From: Mess, Camie
Sent: Wednesday, December 19, 2018 1:25 PM
To: 'Susan Lanterman'
Cc: Werner, Jeffrey B
Subject: December BAR Action - 405 Altamont Street

BAR 18-12-02
405 Altamont Circle
Tax Parcel 330113000
4m & Dice LLC, Owner/Jeffery Lanterman, Applicant
Exterior painting, roof replacement, and dormer addition

**CITY OF CHARLOTTESVILLE
BOARD OF ARCHITECTURAL REVIEW
STAFF REPORT
December 18, 2018**

BAR 18-12-02

EXISTING ELEVATIONS WITH NEW DORMER PLACEMENT

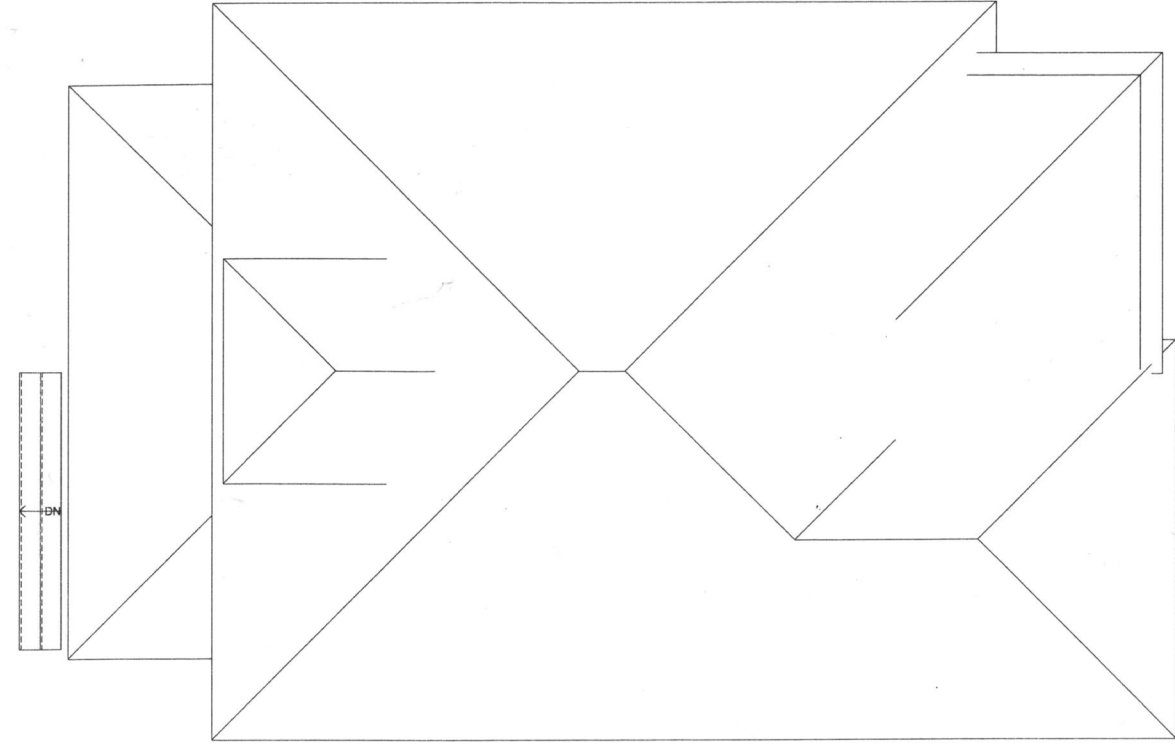
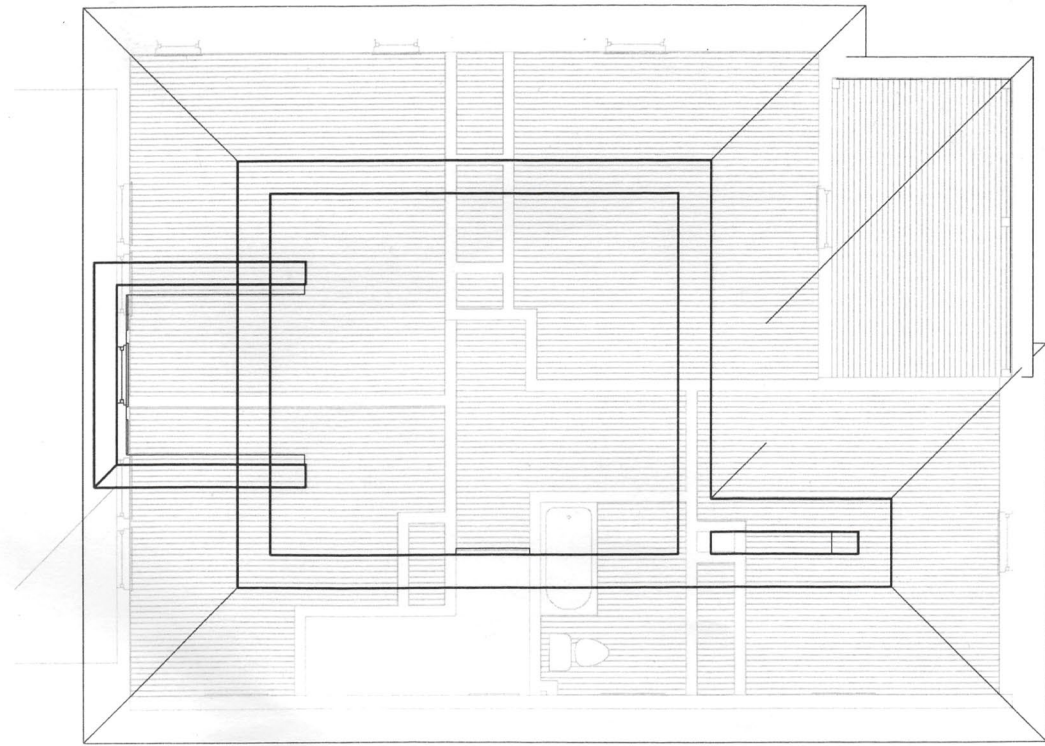
Side dormers on a traditional Foursquare are not unusual. The applicant has provided photos of four nearby houses that have similar side dormers. In fact, within the block surrounding Altamont Circle, no less than eight Foursquare houses feature side dormers. The proposed roof shingles and paint colors are appropriate. Staff recommends approval as submitted.

Having considered the standards set forth within the City Code, including the ADC Guidelines for Rehabilitations, I move to find that the proposed dormer, roof replacement and exterior painting satisfies the BAR's criteria and are compatible with this property and other properties in the North Downtown ADC District, and that the BAR approves the application as submitted.
